Subject: NAC's Responses to NRC's Request for Additional Information (NAC-STC Submittal 17D)

Docket No. 71-9235

FOR REVIEW OF THE CERTIFICATE OF COMPLIANCE NO. 9235, STC
TRANSPORTATION PACKAGE

Figure 2-28: Seal Life at Temperature

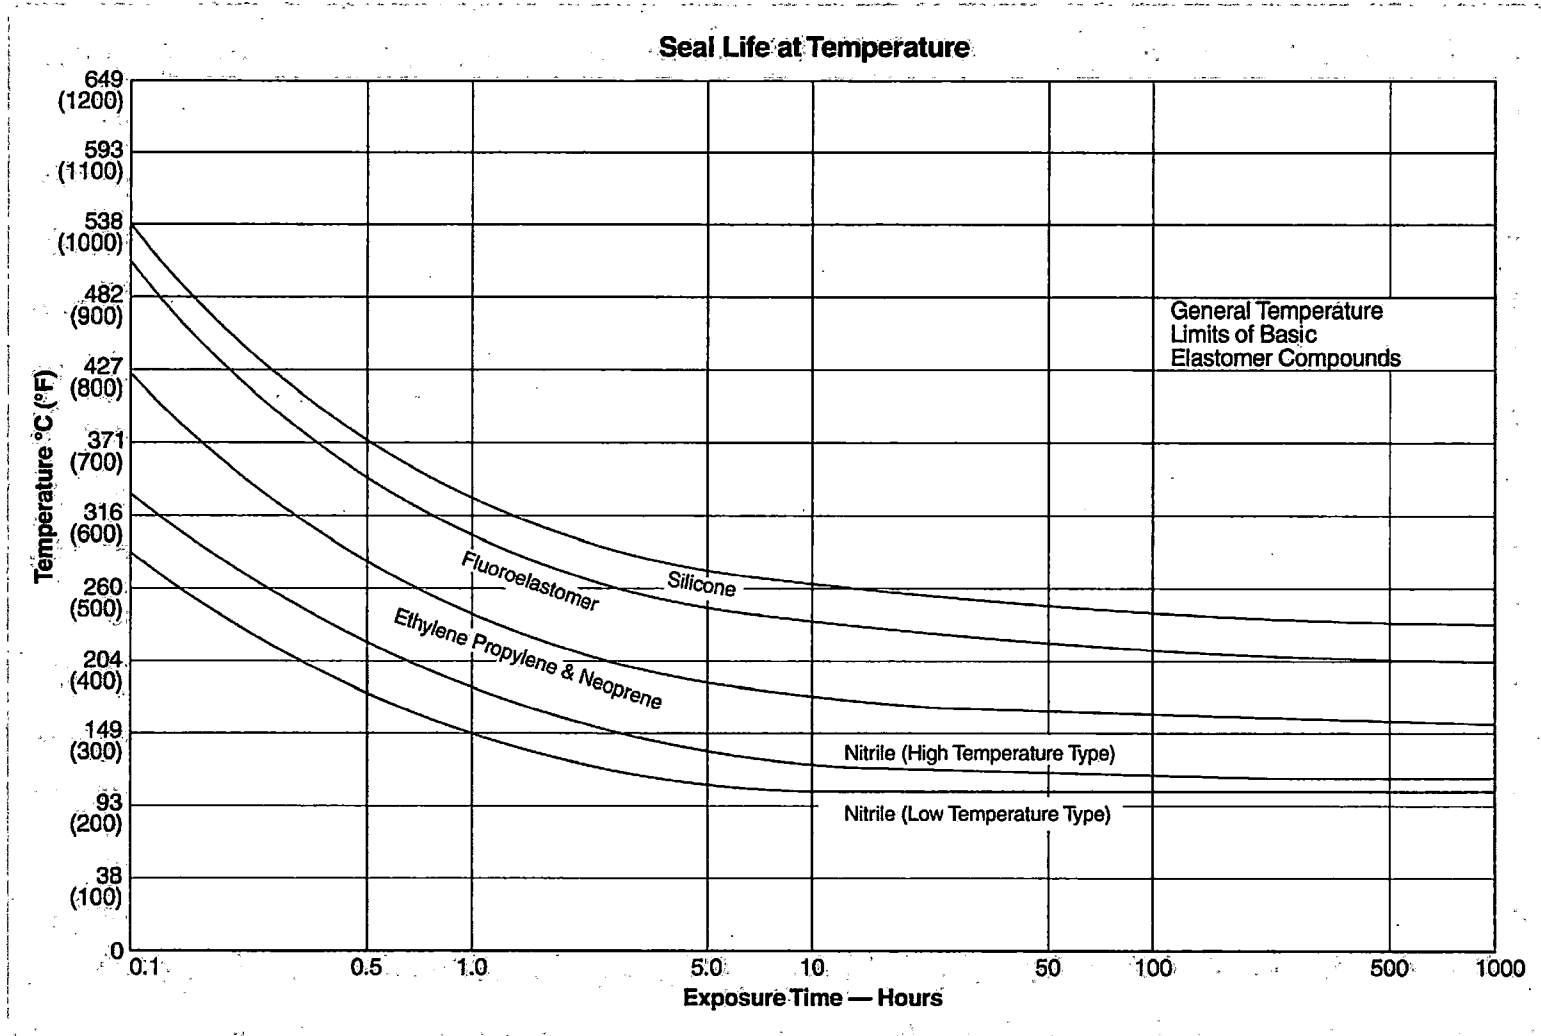
- 2.1 Justify the acceptance criteria (specification limits) assumed for the high-temperature properties of the elastomeric inner lid O-ring during the fire transient condition.

The applicant provided laboratory test data for the high-temperature properties of the O-ring during the fire transient condition, per the requirement in Title 10 of the *Code of Federal Regulations* (10 CFR) 71.73(c)(4) (Figure R-3, Calculation 423-3000, Revision 5). The data was acquired at a higher temperature than the actual maximum temperature that would be reached by the inner lid O-ring during the hypothetical fire condition. The laboratory test report defines an acceptance criteria (specification limits) for allowable changes to the O-ring properties; however, the application does not define the adequacy of these specification limits per the assumptions in the design-basis containment and structural analyses or models. The test results should demonstrate adequate margin of safety for the assumed specification limits.

NAC has provided the vendor's laboratory test report for high temperature properties measured, i.e. "spec limits", for those same physical properties which validate the material's performance for the recommended temperature range of -40°F to 400°F. Specification Limits for the Dry Heat Resistance test were all met. As NAC's application is only 418°F for 1.5 hours, the test results indicate the material exposed to a higher temperature for a significantly longer period will maintain its performance characteristics. Further, NAC is providing the vendor's "Seal Life at Temperature" graph, Figure 2-28, from the Parker O-ring Handbook (ORD-5700), which indicates the VM835 Fluoroelastomer has a seal life of almost 100 hours at 418°F. See the following page for a copy of this figure.
